MODEL BD-100-1A10 (CL-300)

REWORK – WING TANK – ADDITION OF SEALANT TO FACILITATE WATER DRAINAGE FROM WING FUEL TANKS AND PREVENT ERRATIC FUEL INDICATIONS

SERVICE BULLETIN

**REWORK – WING TANK – ADDITION OF SEALANT TO FACILITATE
WATER DRAINAGE FROM WING FUEL TANKS AND
PREVENT ERRATIC FUEL INDICATIONS**

SB100-28-08-70228-A-S1-3

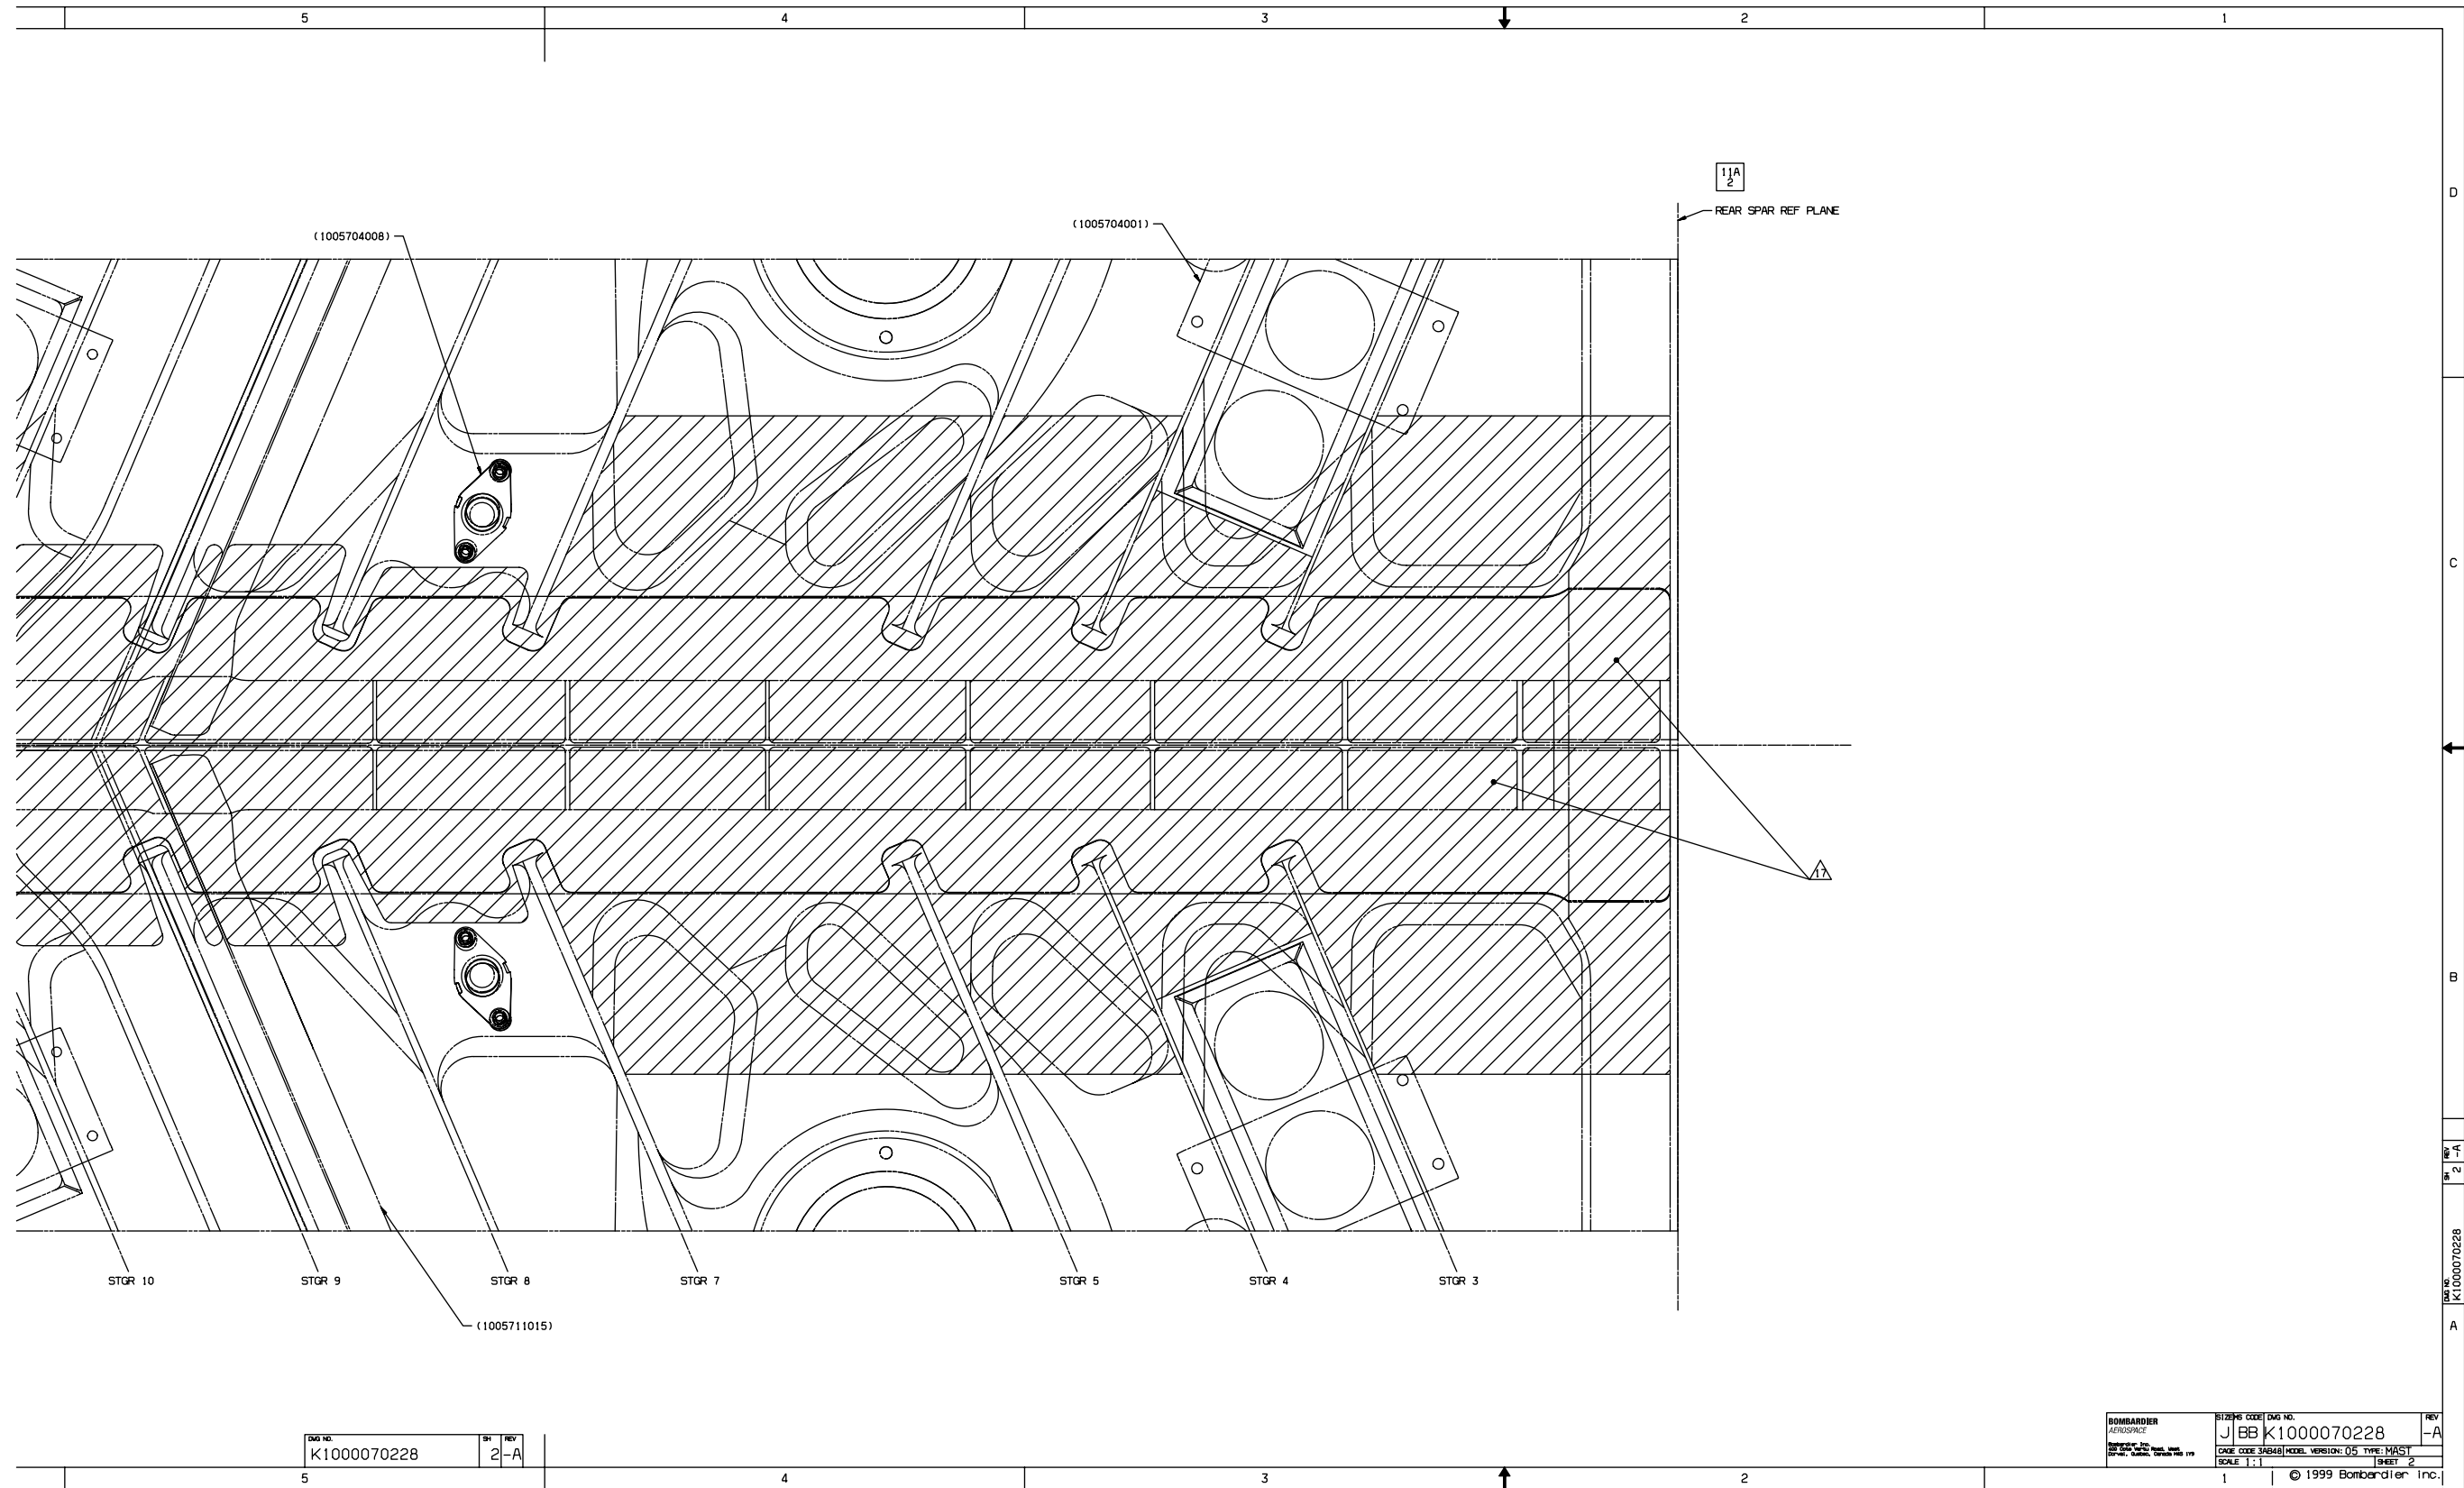
- (1) Using a non-metallic tool, remove the sealant to provide water drainage paths in all areas identified as flag note 14. Refer to Kit Drawing K1000070228; view A-A, sections E-E and R-R.
NOTE: The use of paint remover to soften sealant is not permitted.
- (2) Using a non-metallic tool, remove sealant in areas identified as flag note 18 as necessary to create a water drainage path. Refer to Kit Drawing K1000070228; flag note 14, 18 and view A-A.
- (3) Prepare areas indicated by flag note 13 of Kit Drawing K1000070228, view A-A, sections L-L, N-N, and P-P for thermal insulation sealant application as follows:
 - (a) Using a Scotch-brite, sand the exposed surface of the cured sealant.
 - (b) Vacuum and clean the area to be sealed. Refer to TASK 51-25-00-110-801.
